OVERALL BASEMENT

OVERALL LEVEL 1

OVERALL LEVEL 2

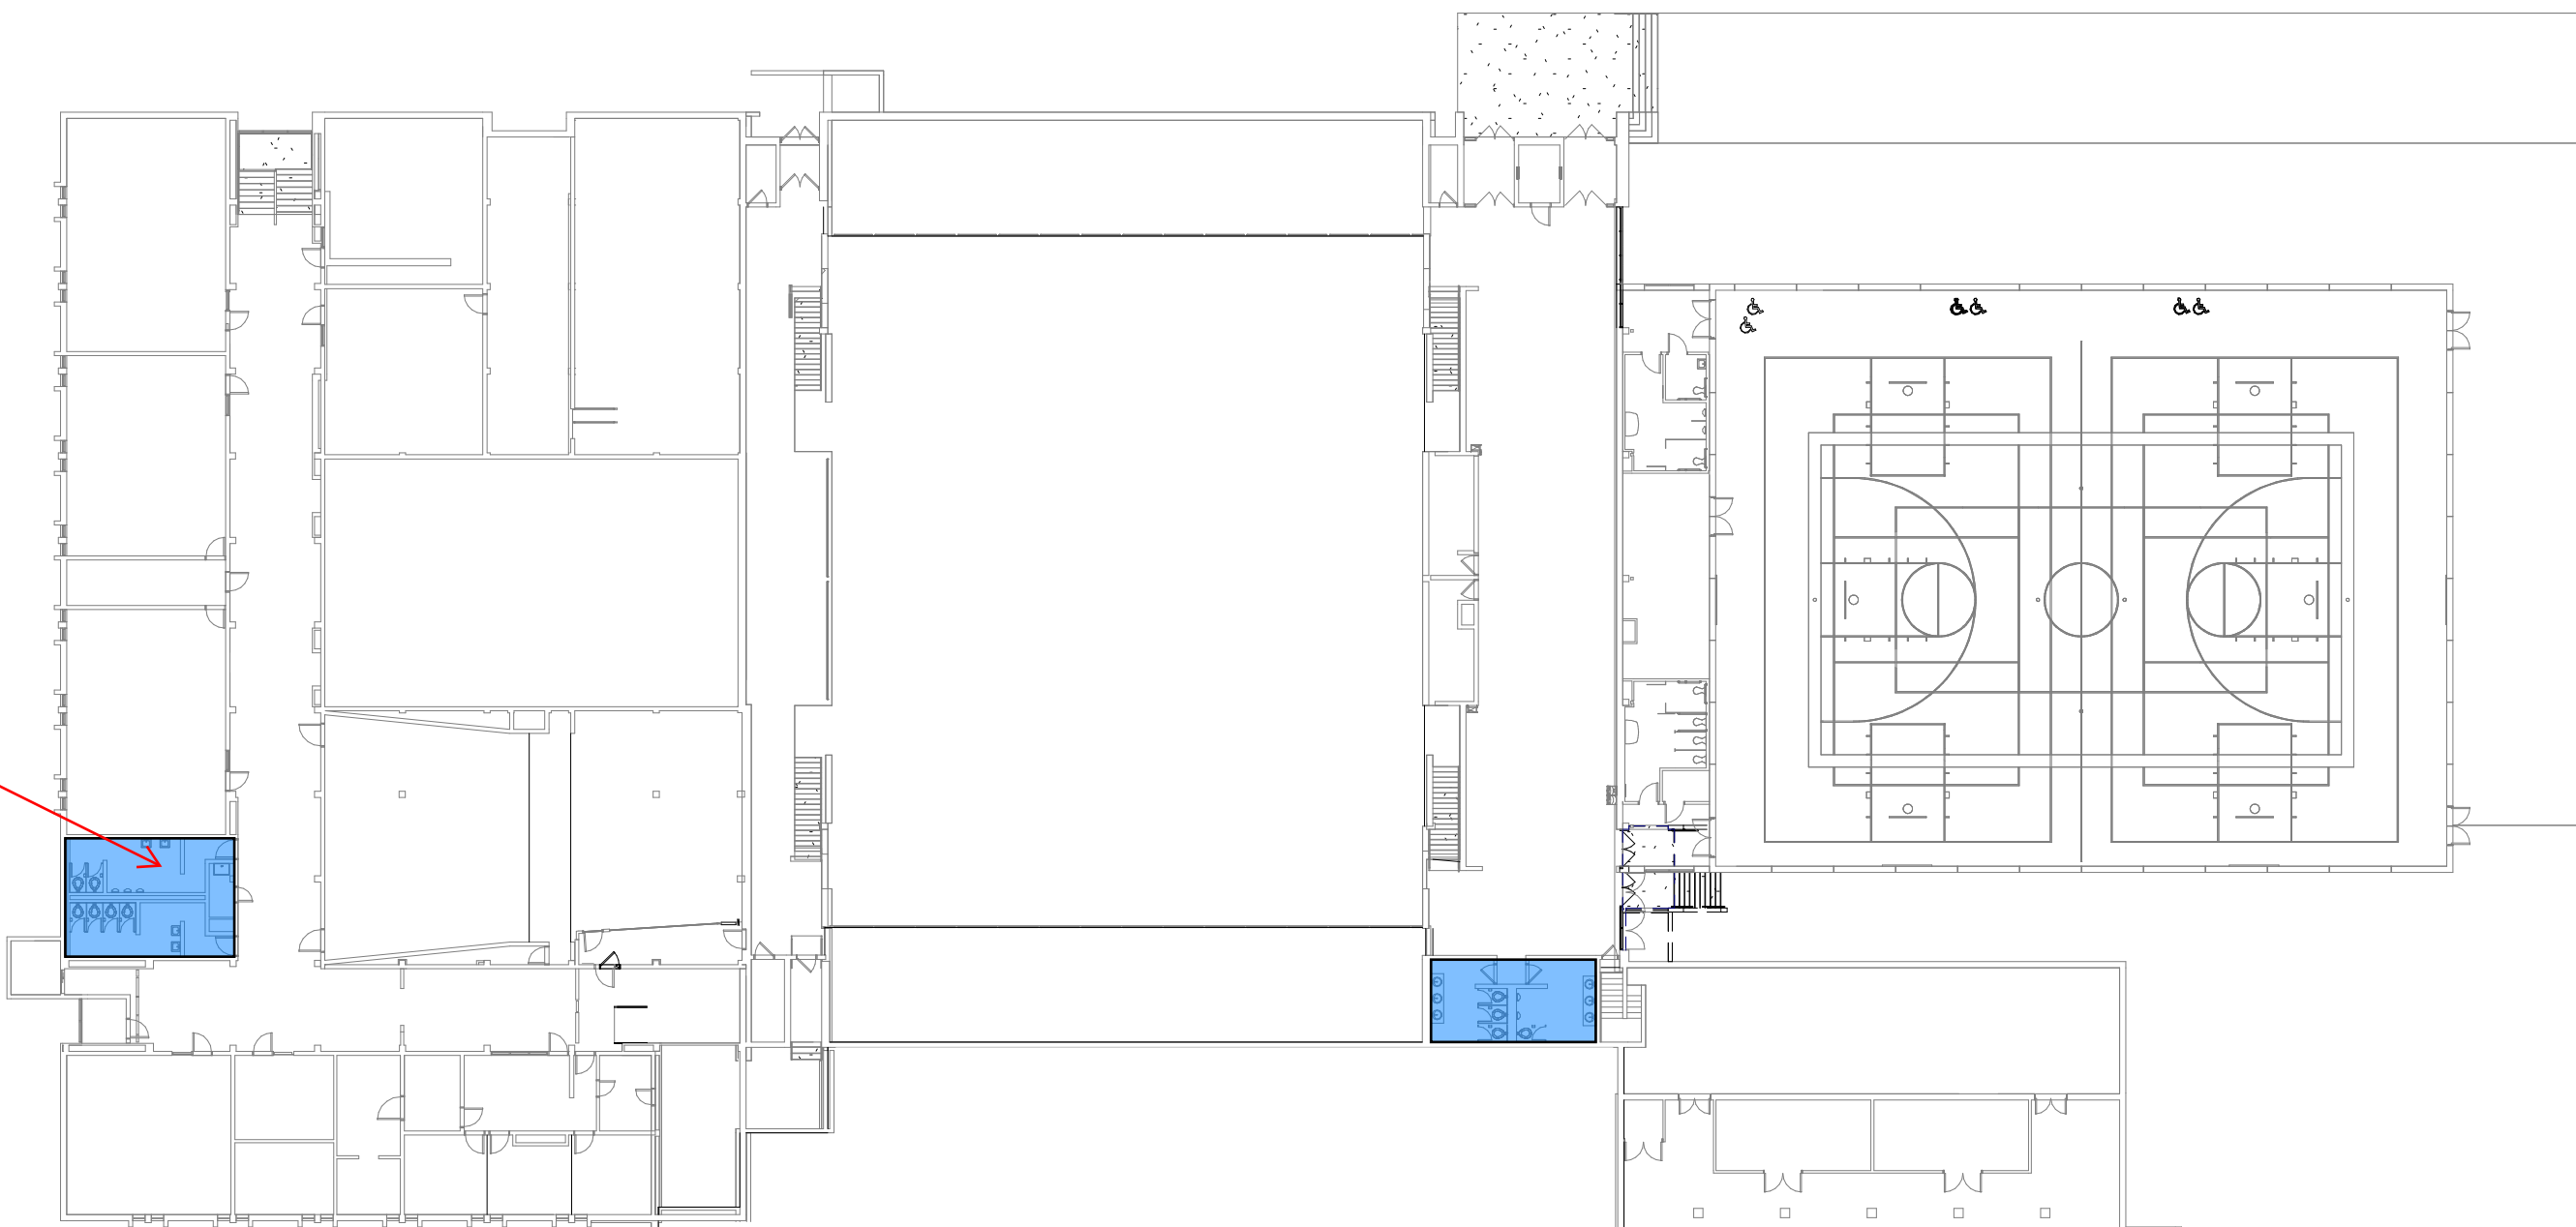
**FIRE ALARM SYSTEM OBSOLETE, DIFFICULT TO MAINTAIN.**

**TOILETS NOT ACCESSIBLE**

**KITCHEN FINISHES NOT COMPLIANT**

**LUNCHROOM UNDERSIZED FOR PK-12**

**BLEACHER RAILINGS AND STEPS NOT COMPLIANT**

**GYM HVAC NOT COMPLIANT FOR IAQ AND DOES NOT HAVE COOLING**

**ROUTE FROM ELEMENTARY TO LUNCHROOM AND PLAYGROUND NOT ACCESSIBLE**

**SCIENCE LABS DO NOT HAVE ACCESSIBLE LAB STATION. 2 EXITS REQUIRED**

**TOILETS AND SHOWERS NOT ACCESSIBLE**

**HEAD START ROOM IN HIGH SCHOOL. NO TOILET IN ROOM**

**TOILETS AND SHOWERS NOT ACCESSIBLE**

**WRESTLING HVAC NOT COMPLIANT FOR IAQ**

**ORIGINAL ELECTRICAL SERVICE SWITCHGEAR OBSOLETE**

**FIRE ALARM SYSTEM OBSOLETE, DIFFICULT TO MAINTAIN.**

**WOOD SHOP UNDERSIZED. NO EXTERIOR ACCESS FOR MATERIALS AND PROJECTS**

**SHOP LAYOUT DOES NOT SUPPORT DESIRED CURRICULUM**

**WELDING EXHAUST IN POOR CONDITION**

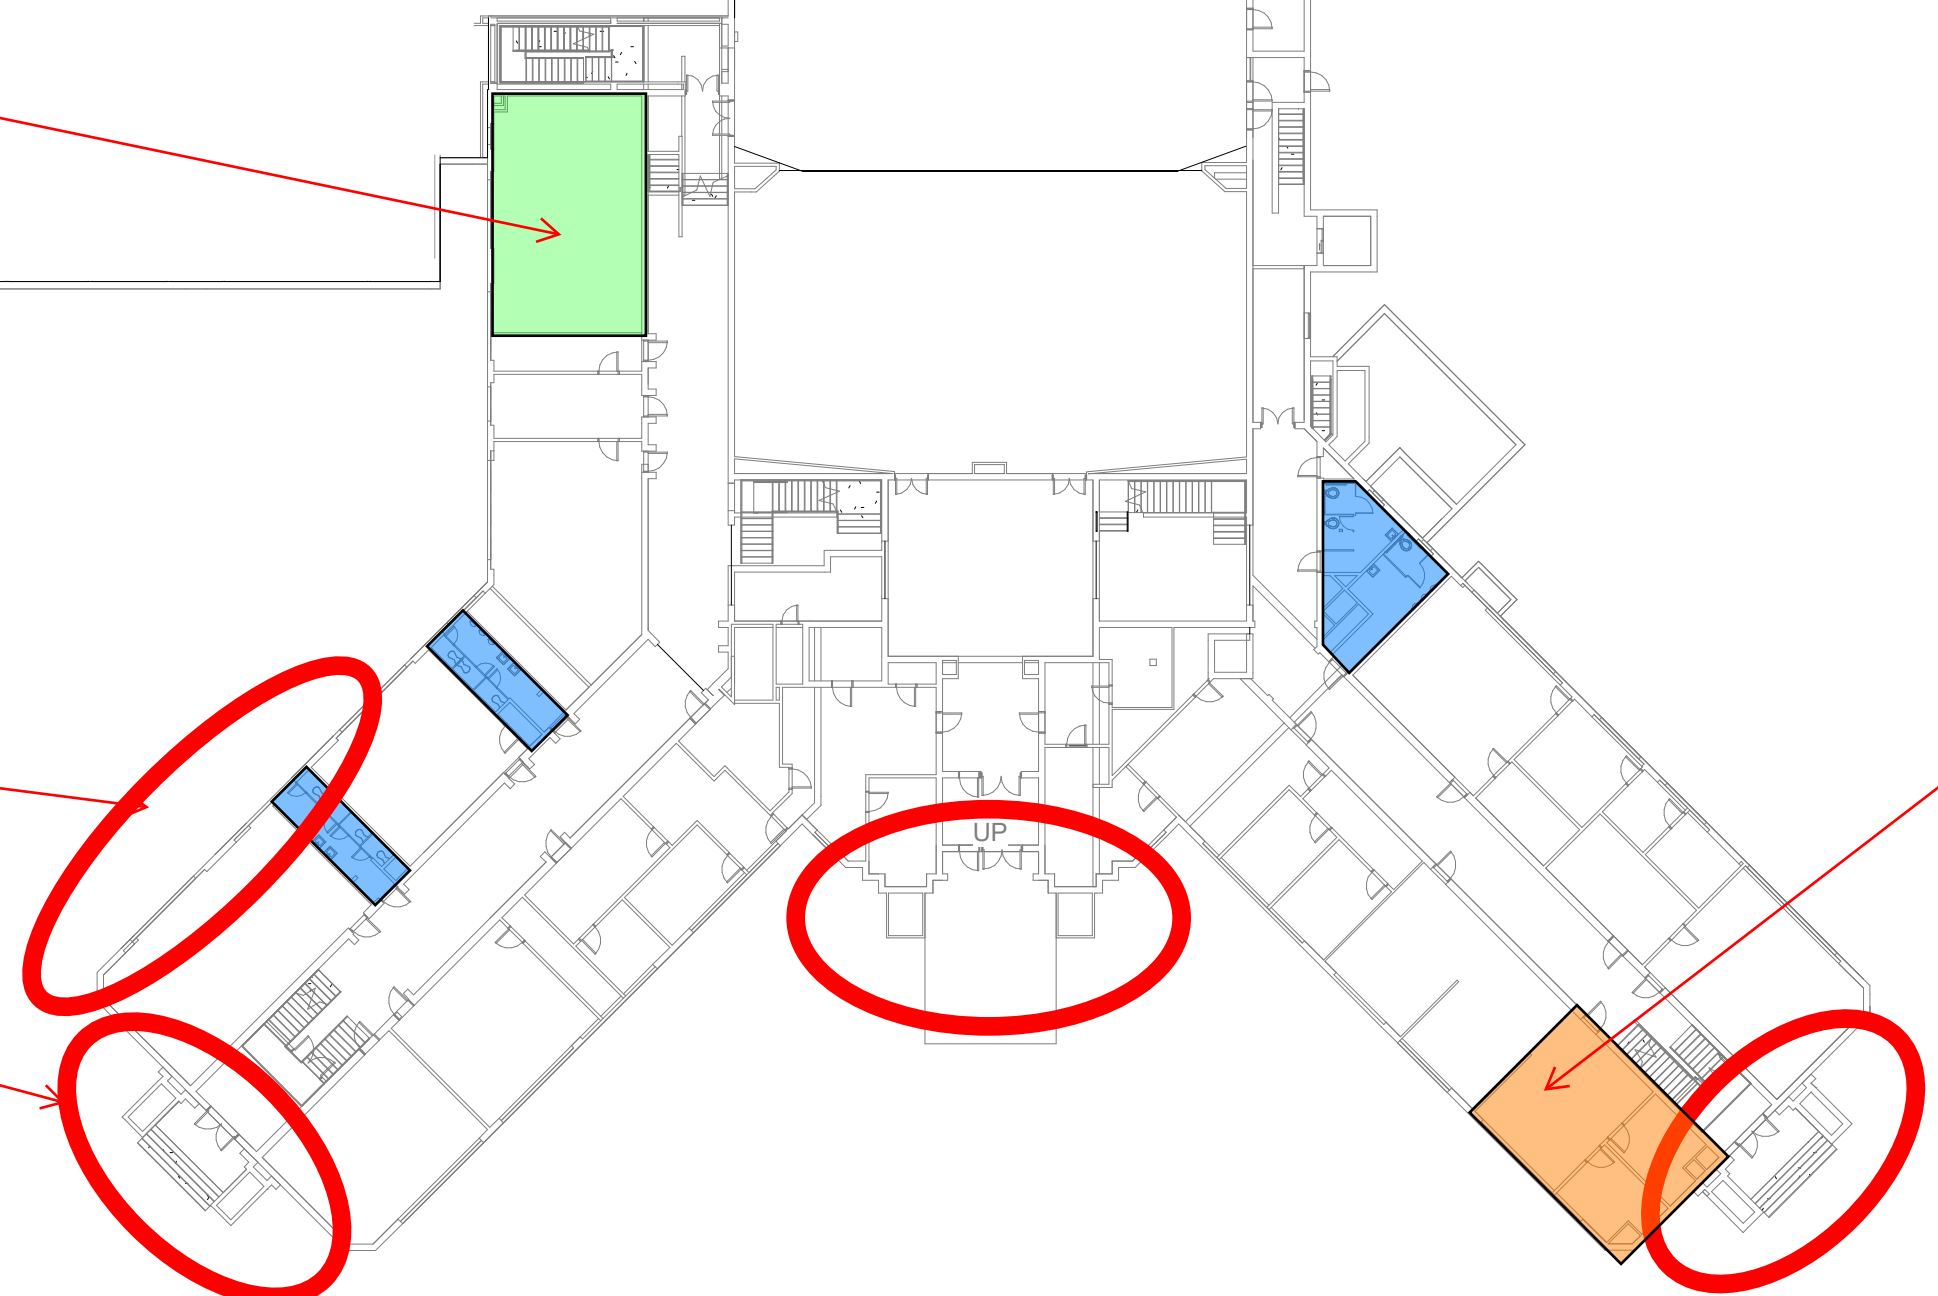
ENTRANCE / EXITS NOT ACCESSIBLE - TYPICAL AT ELEMENTARY

TOILETS NOT ACCESSIBLE - TYPICAL AT ELEMENTARY

CLASSROOM CASEWORK / SINKS IN POOR CONDITION - TYPICAL AT ELEMENTARY

SECURE ENTRY DIFFICULT TO SUPERVISE

TOILETS NOT ACCESSIBLE - TYPICAL AT HIGH SCHOOL

FOODS LABS DOES NOT HAVE ACCESSIBLE KITCHEN. 2 EXITS REQUIRED

FOODS LAB DESIGN DOES NOT SUPPORT DESIRED CURRICULUM

MASONRY DETERIORATED AT WEST WALL AND ENTRANCES OF Y-WING  
STEPS AT ENTRIES ARE IN POOR CONDITION

DISTRICT OFFICE LAYOUT NOT EFFICIENT

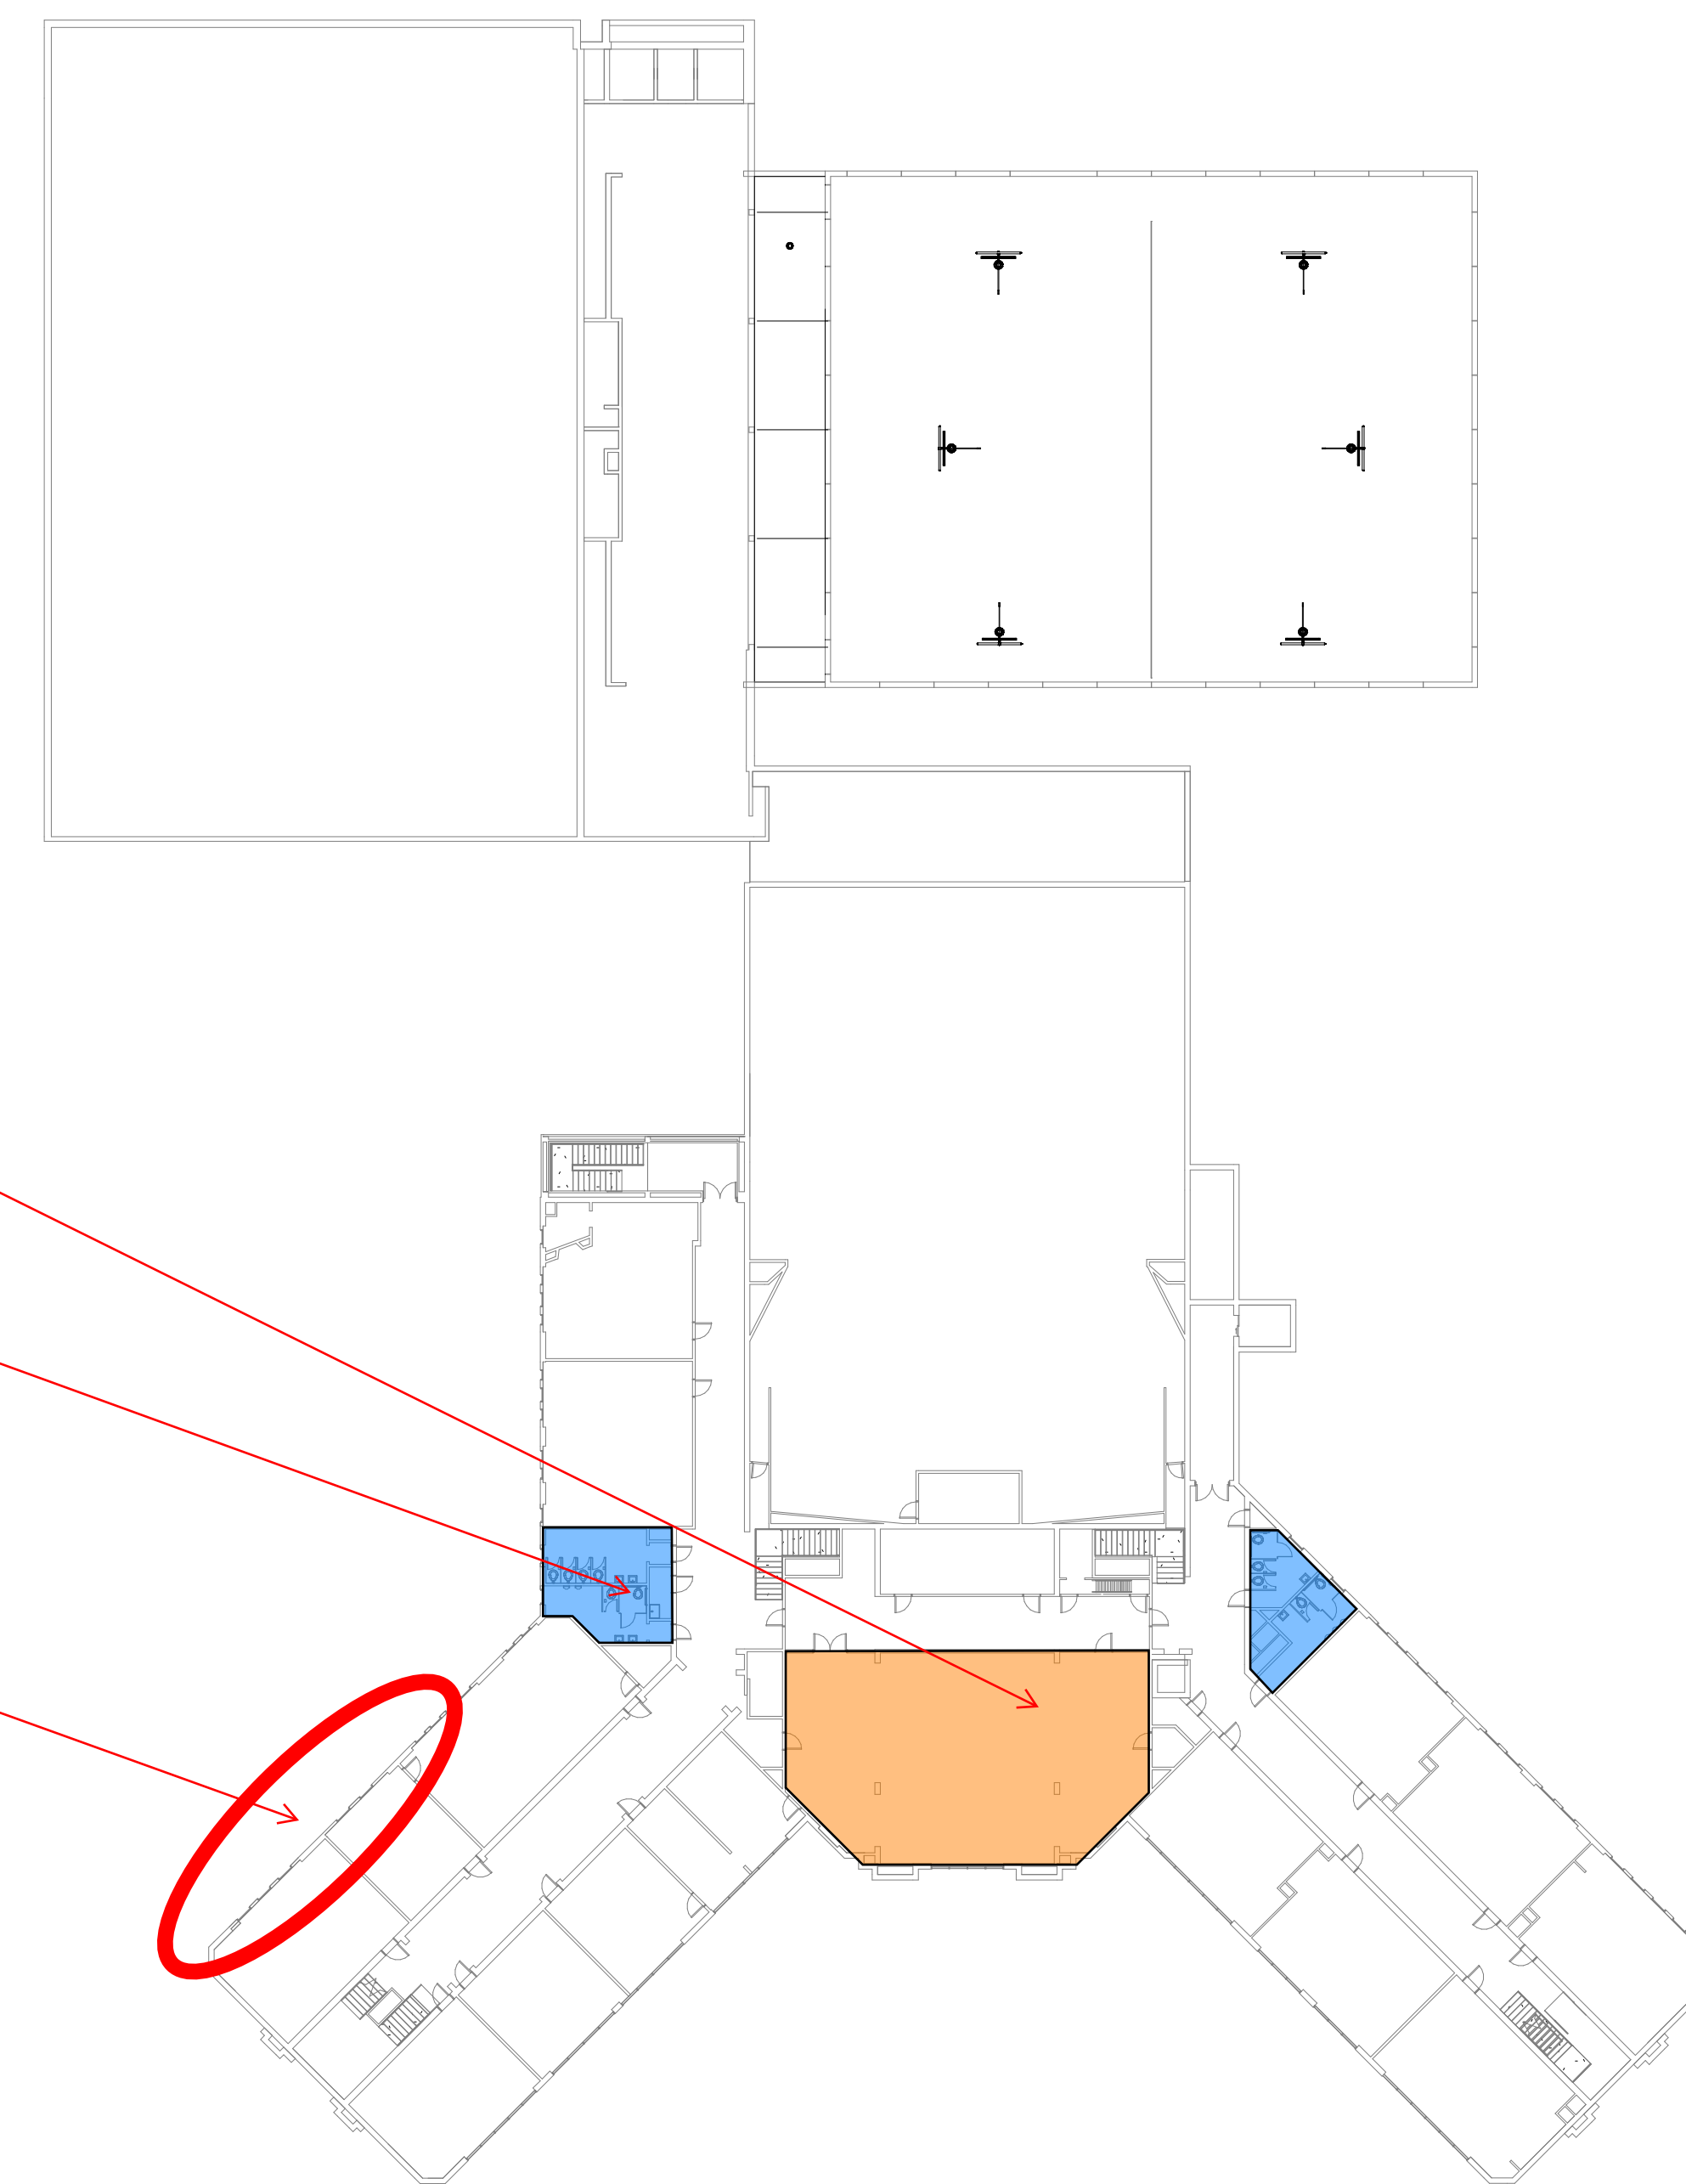
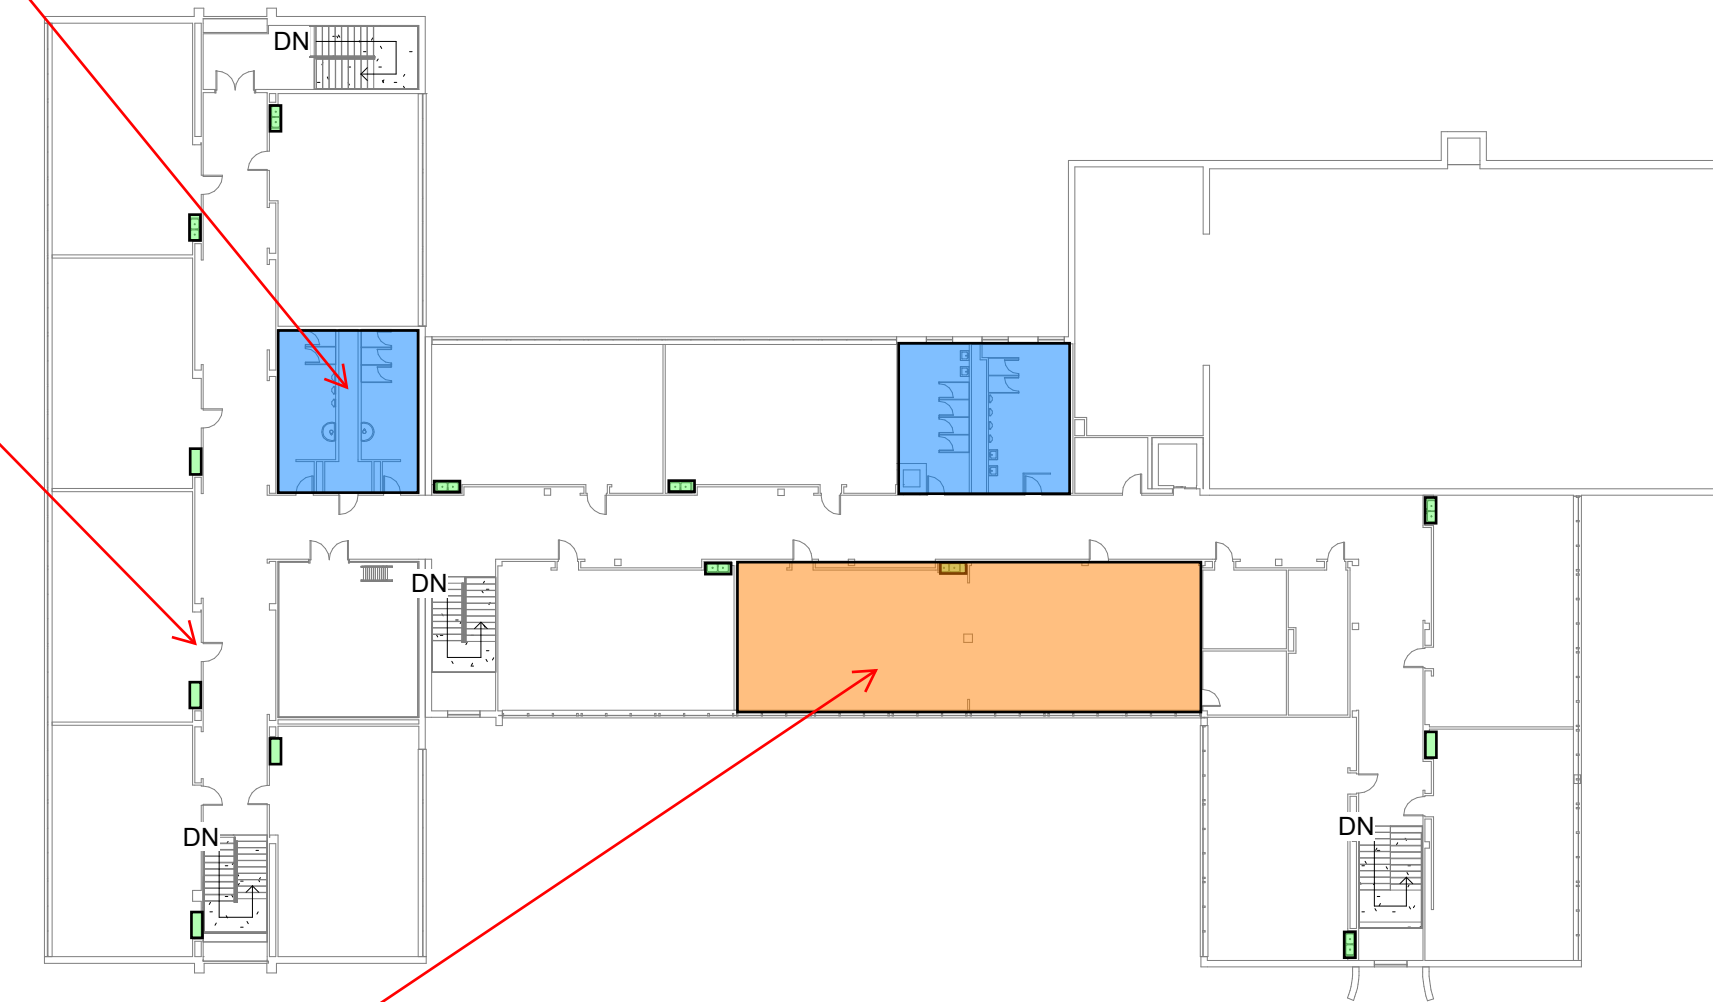
TOILETS NOT ACCESSIBLE  
- TYPICAL AT ELEMENTARY

CLASSROOM CASEWORK /  
SINKS IN POOR CONDITION-  
TYPICAL AT ELEMENTARY

MEDIA CENTER LAYOUT  
DOES NOT SUPPORT  
CURRENT PROGRAMS

MEDIA CENTER LAYOUT  
DOES NOT SUPPORT  
CURRENT PROGRAMS

TOILETS NOT ACCESSIBLE -  
TYPICAL AT HIGH SCHOOL

MASONRY DETERIORATED  
AT WEST WALL AND  
ENTRANCES OF Y-WING
